# Access Compliance Report

### (Curb Ramps)

Intersection ID: 8954	Main Street: THE_PLAZA	Cross Street: JAMES_RD	Location: SE
ADA ID: 773C6A307C4D	Ramp Type: Combination1	Initial Pass/Fail: Fail	Overall Compliance: No
		Severity Score: 60

#### Codes/Mitigation Info/Possible Solution

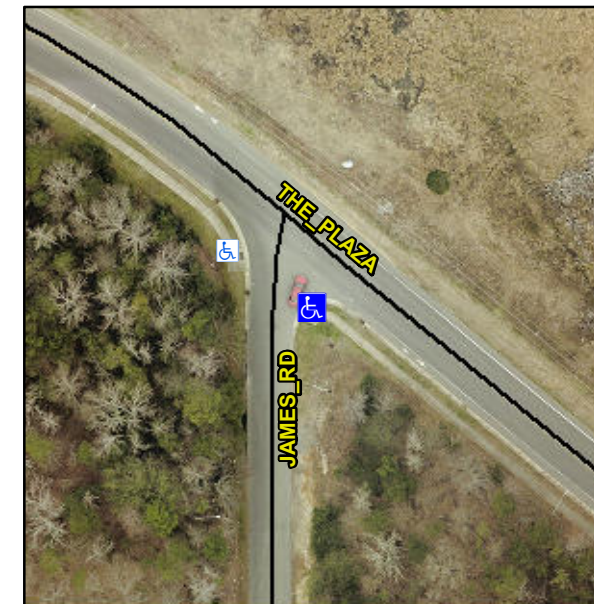
**Not Found, R304.5.1, R304.5.1, R304.2.2, R304.5.3, R304.3.2**

Compliance	Description	Data	Compliance	Description	Data
N/A	Ramp Length LT (in)	19.5	N/A	Ramp Length RT (in)	59.5
Yes	Ramp Width LT (in)	59.5	No	Ramp Width RT (in)	29.0
Yes	Ramp Slope LT (%)	6.5	No	Ramp Slope RT (%)	9.8
Yes	Ramp XSlope LT (%)	0.4	Yes	Ramp XSlope RT (%)	1.4
N/A	Ramp Length (in)	48.0	No	Ramp Slope (%)	9.2
No	Ramp Width (in)	47.0	No	Ramp XSlope (%)	5.2
N/A	Flare Type LT	N/A	N/A	Flare Type RT	N/A
N/A	Flare Slope LT (%)	N/A	N/A	Flare Slope RT (%)	N/A
N/A	Flare Traversable LT?	N/A	N/A	Flare Traversable RT?	N/A
N/A	Landing Length (in)	N/A	N/A	DWS Provided?	N/A
N/A	Landing Width (in)	N/A	N/A	DWS Contrast?	N/A
N/A	Landing Slope (%)	N/A	N/A	DWS Length (in)	N/A
N/A	Landing X Slope (%)	N/A	N/A	DWS Full Width?	N/A
N/A	Landing Curb? (Y/N)	N/A	N/A	DWS Offset (in)	N/A
N/A	Shared Landing?	N/A			
N/A	Gutter Ponding?	N/A	N/A	Gutter Slope (%)	N/A
N/A	Gutter Lip Ht (in)	N/A	N/A	Gutter X Slope (%)	N/A
N/A	Painted X Walk1?	No	N/A	Painted X Walk2?	N/A

**Remove & Replace Entire Ramp.**
